| NIHVA TECHNOLOGIES PVT. LTD. | Vendors Inspection | | | Format No.: NIHVA-QA-F- 07 |

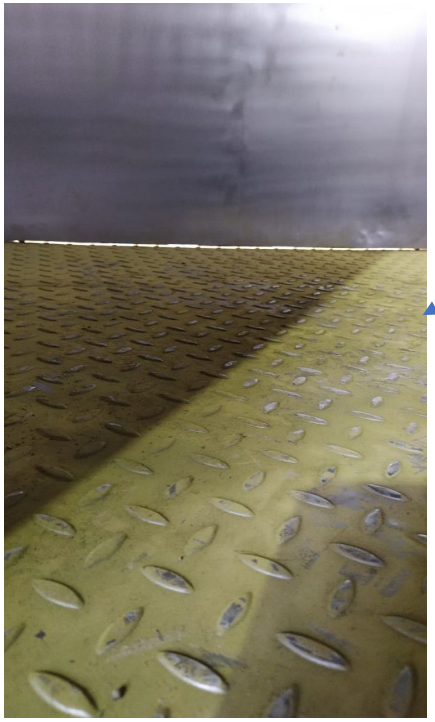
Strength of this assembly is very less

Gap observed between platform & Vertical Cabin

Outside light seen from inside
